City of Tukwila

**STAFF REPORT TO
THE BOARD OF ARCHITECTURAL REVIEW
PREPARED August 14, 2013**

FILE NUMBER: PL13-011 – Parent File for:
L13-011 -- Red Lobster Restaurant
L13-012 -- Seasons 52 Restaurant

REQUEST: L13-011: Design Review approval for a new 5,880 sf Red Lobster restaurant with associated parking, site improvements and landscaping; and
L13-012: Design Review approval for a new 9,054 sf Seasons 52 restaurant with associated parking, site improvements and landscaping.

Graphic 1

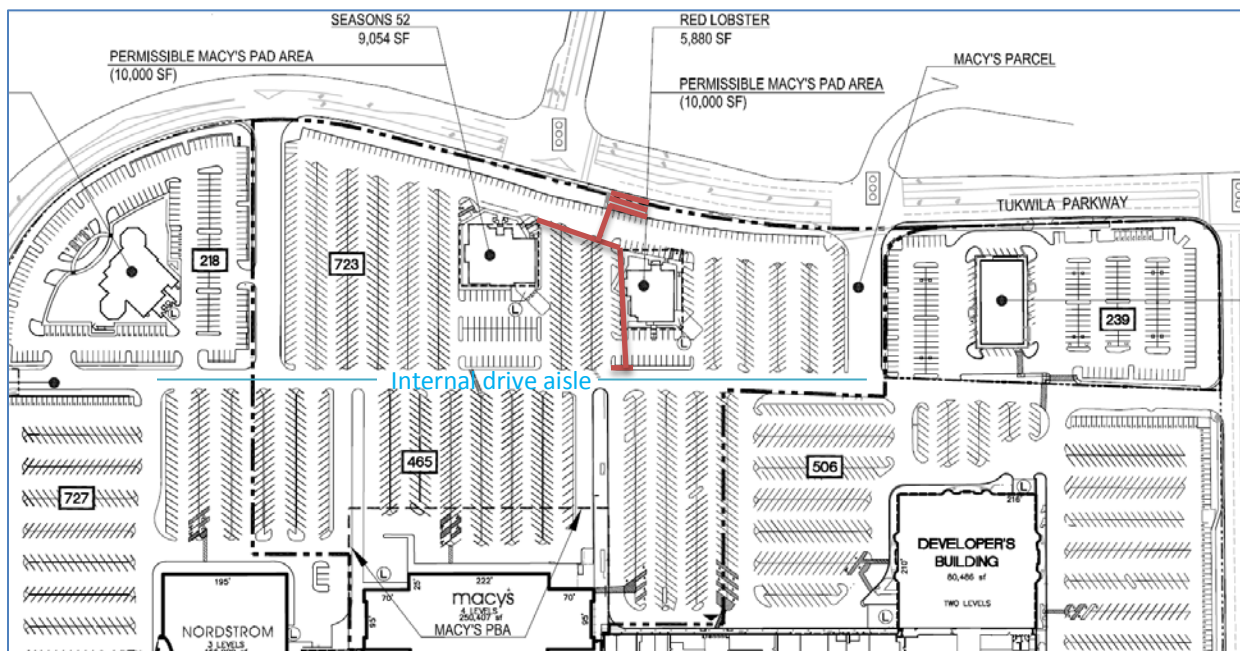
The site design includes a new ADA-accessible, pedestrian ramp from Tukwila Parkway to the parking area. The ramp will connect to a pedestrian path that will continue to the south, split to access each restaurant after crossing the north drive aisle of the parking area and then continue along the west side of the Red Lobster building across the south parking area and to a sidewalk along the main access drive to the south. It connects to an existing crosswalk which leads to the wide, paved sidewalk along the east side of Macy's and to the main Mall entrance on the north side. The applicant has indicated concrete will be the material for the pedestrian path across its entire length. This material change will visually draw attention to the pedestrian route of travel where it crosses the asphalt parking lot. (Where the pedestrian route is also the Red Lobster building perimeter sidewalk, this distinction will be lost.)

The plans provided show the pedestrian path on each restaurant site but the overall site development plan does not show the proposed pedestrian path. The following drawing roughly depicts in red the location of the pedestrian path as proposed and the internal drive aisle that is referred to throughout this report:

The pedestrian path from the north to the south will be paved in concrete. The material change (from asphalt) will distinguish the pedestrian way. To further clarify the pedestrian way where it simultaneously functions as the concrete sidewalk around the Red Lobster, color could be added to the concrete to distinguish the pedestrian route from the building perimeter sidewalk.

1. The pedestrian path, as shown in Graphic 1 of this report, from the ADA-ramp to the landscaping on the south limits of the parcel, shall be in colored concrete. The intent of the color will be to draw attention to the pedestrian route and to distinguish it from the building perimeter sidewalk on the Red Lobster site. The color may be determined at the building permit stage.

Graphic 2

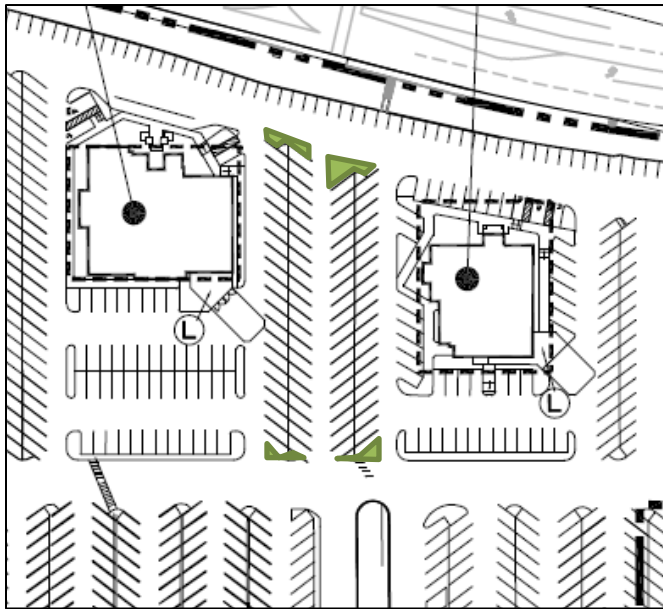
The site could be further enhanced through the addition of landscape islands at the north and south ends of the angled parking between the two buildings. This would further define the internal drive aisle as well as shield the pedestrian crossing along the north.

Graphic 1 on page 4 of this report shows the area of colored concrete in red. Graphic 2, below, shows the location of additional landscape islands that are recommended as a condition of approval of this design review application:

2. Landscape islands to be added at to north and south ends of the two drive-aisles running north-south between the two restaurants as shown in Graphic 2 of this report.
